UNITED STATES PATENT AND TRADEMARK OFFICE

| APPLICATION NO. | FILING DATE | FIRST NAMED INVENTOR | ATTORNEY DOCKET NO. | CONFIRMATION NO. |
|-----------------|-------------|-----------------------|---------------------|------------------|
| 09/474,299 | 12/29/1999 | MARCEL F.C. SCHEMMANN | PHA-23.939 | 2088 |

| Office Action Summary | Application No. 09/474,299 | Applicant(s) SCHEMMANN ET AL. | |

DETAILED ACTION

FIG. 6

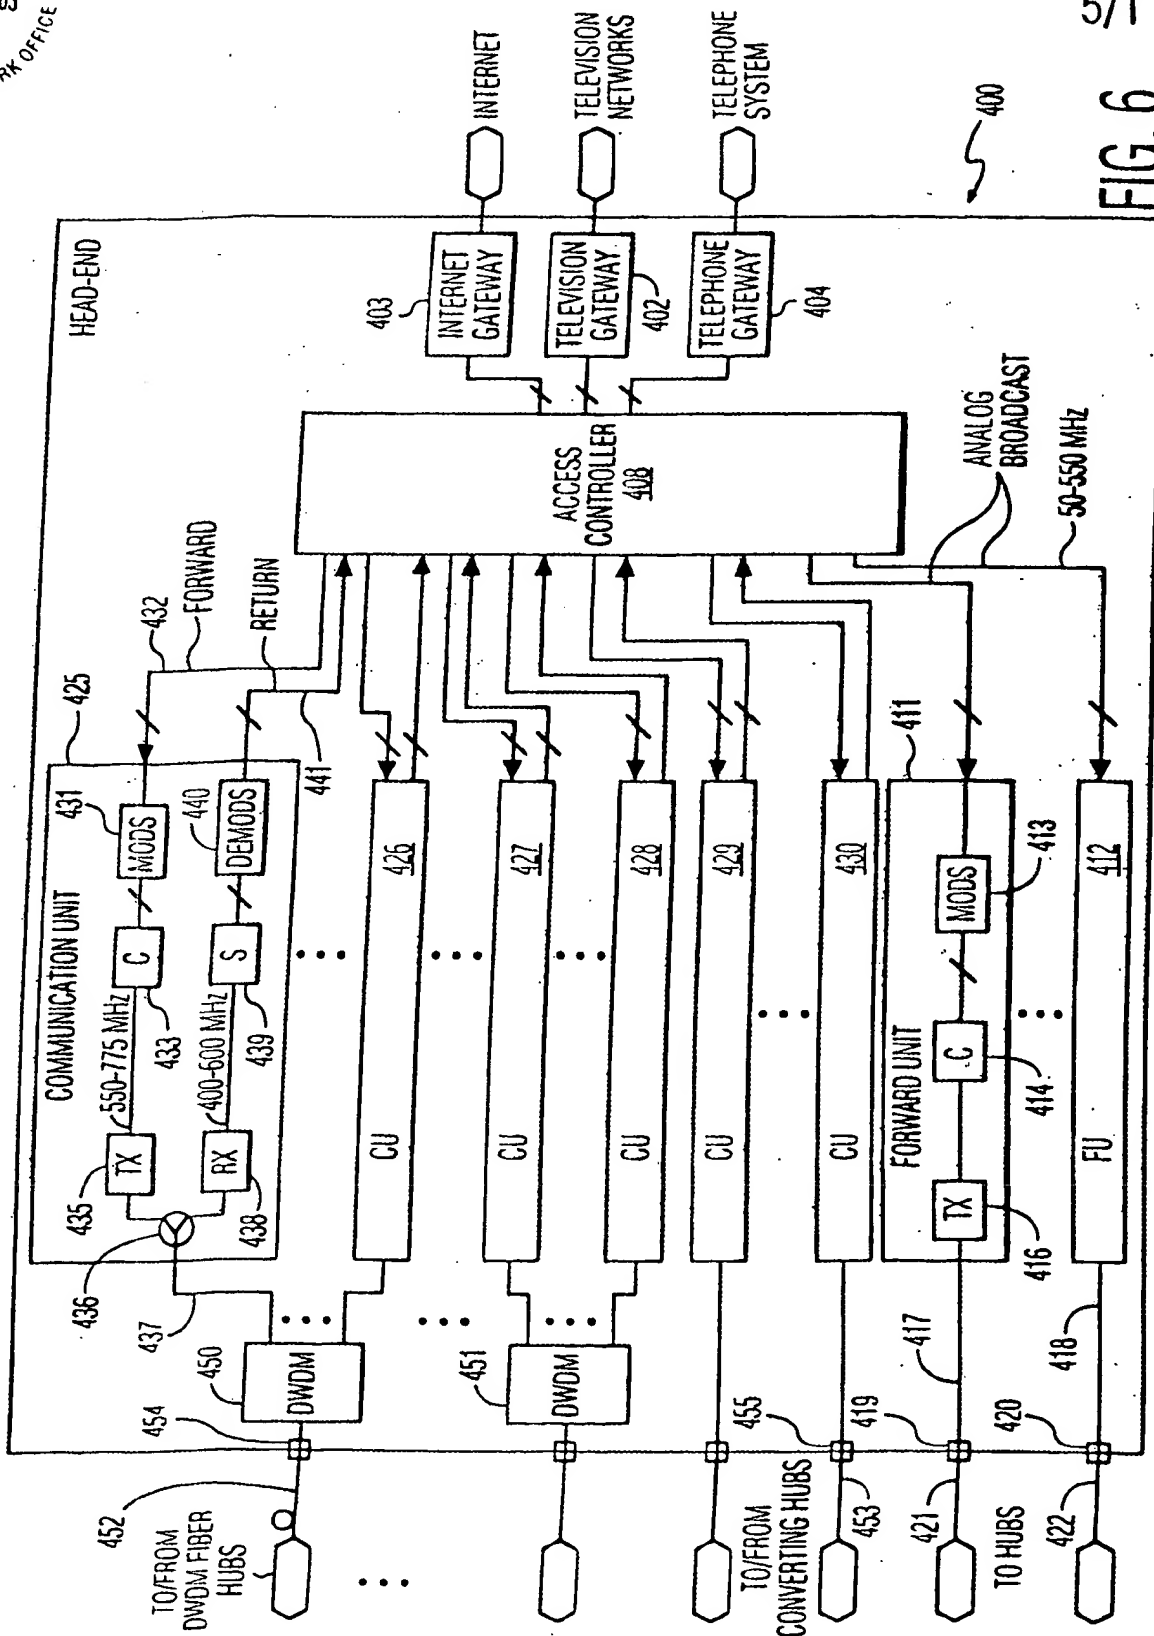
1. Applicant's compliance with the objections to the drawings in the previous Office Action (mailed on 18 November 2004) is noted and appreciated. Replacement drawing sheets were received on 18 February 2005. Fig. 6 is approved. However, Figs. 5 and 7 are still disapproved. Upon further review of the drawings and the specification together, the Office has noticed numerous informalities. Some examples include:

Approved by DSK

FIG. 7

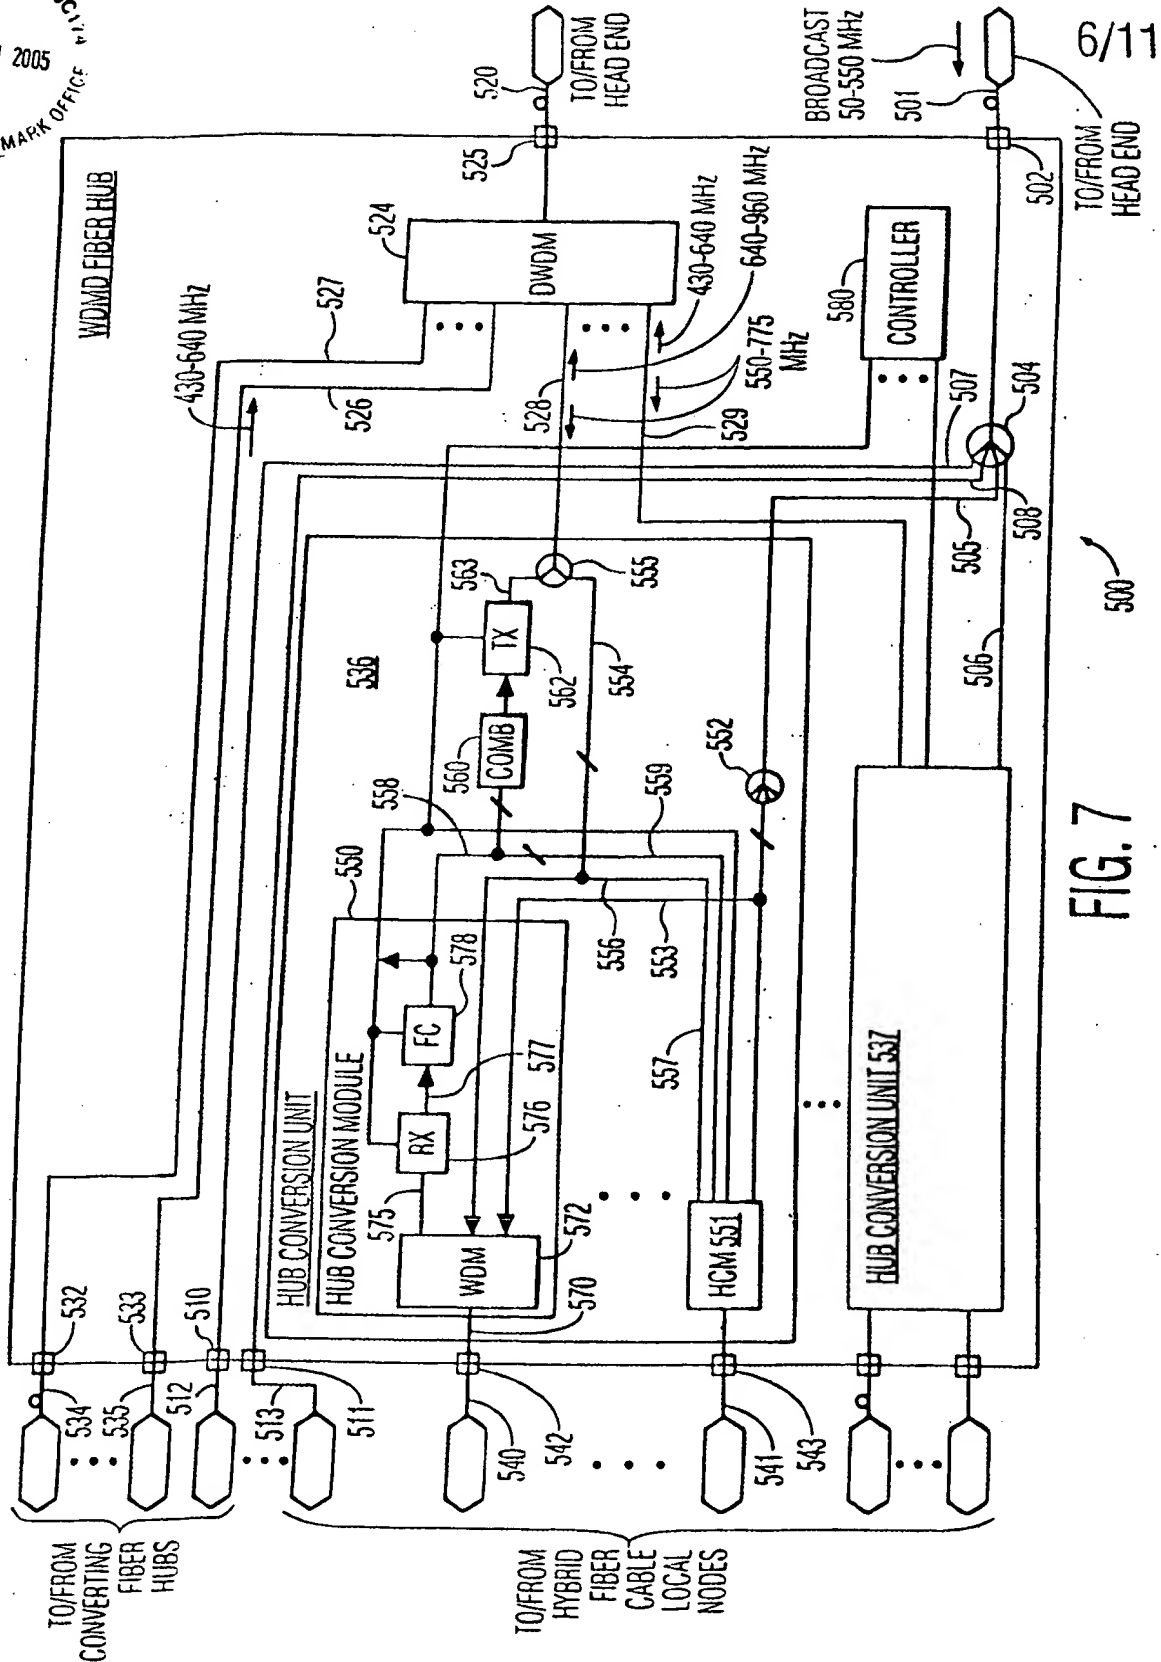
In replacement Fig. 7 (filed on 18 February 2005), reference character "554" appears to be located in the wrong location. The bridging paragraph of p. 35-36 indicates that "554" should label a path that is connected to optical splitter 552.

Disapproved by DSK
11 OCTOBER 2005
